FINAL PLAT

PINE MEADOW ADDITION

RE: SUB 2001-61 -- Final Plat of Pine Meadow Addition

STAFF REPORT

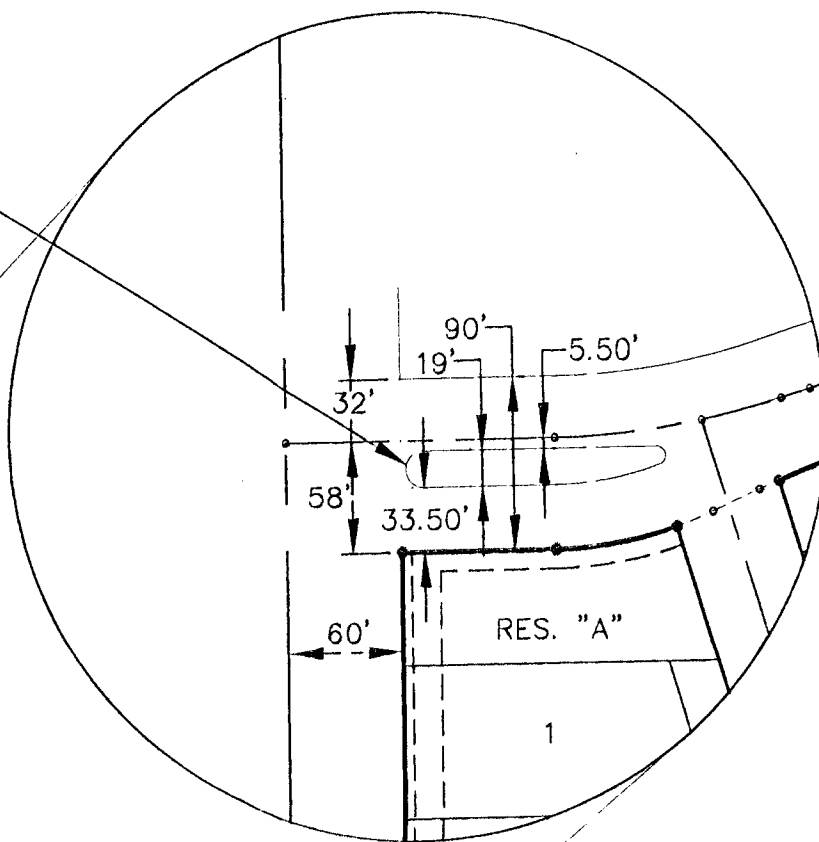
- D. City Engineering needs to comment on the status of the applicant's drainage plan. The drainage plan is approved.
- E. On the final plat tracing, the MAPC signature block needs to reference "J.D. Michaelis, Acting Chair".

- F. On the final plat tracing, the City Council signature block should be revised to denote "At the direction of the City Council" above the signature line of the City Manager.

- G. Complete access control shall be dedicated along Greenwich Road and denoted on the face of the plat.
- H. The Applicant shall guarantee the paving of the proposed streets.

- P. The City Fire Department/GIS needs to comment on the plat's street names. Pine Meadow should be replaced with Killenwood. Gatewood needs to be replaced with Hartmoor or Donegal. Gatewood Court needs to be replaced with Crest Ct (southwest corner) and by Bristol Ct (Southeast corner).

Donegal Lane needs to be revised to Donegal.
- Q. The wall easement needs to be referenced in the plat's text.
- R. A bearing needs to be added along the north line of Lot 19, Block 1.
- S. The centerline of Killenwood needs to be located along Greenwich Road.
- T. A right-of-way width needs to be added for the west end of Killenwood.
- U. The legal description needs to be corrected to remove lines that are repeated.

- V. *Traffic Engineering has requested a petition for the construction of a future decel lane along Greenwich.*
- W. The platlor's text shall include language that a drainage plan has been developed for the plat and that all drainage easements, rights-of-way, or reserves shall remain at established grades or as modified with the approval of the applicable City or County Engineer, and unobstructed to allow for the conveyance of stormwater.

- EE. The representatives from the utility companies should be prepared to comment on the need for any additional utility easements to be platted on this property. *KGE has requested additional easements.*

The street names have been revised as requested.

- EE. The representatives from the utility companies should be prepared to comment on the need for any additional utility easements to be platted on this property. ***KGE has requested additional easements, which have been denoted on the final plat.***
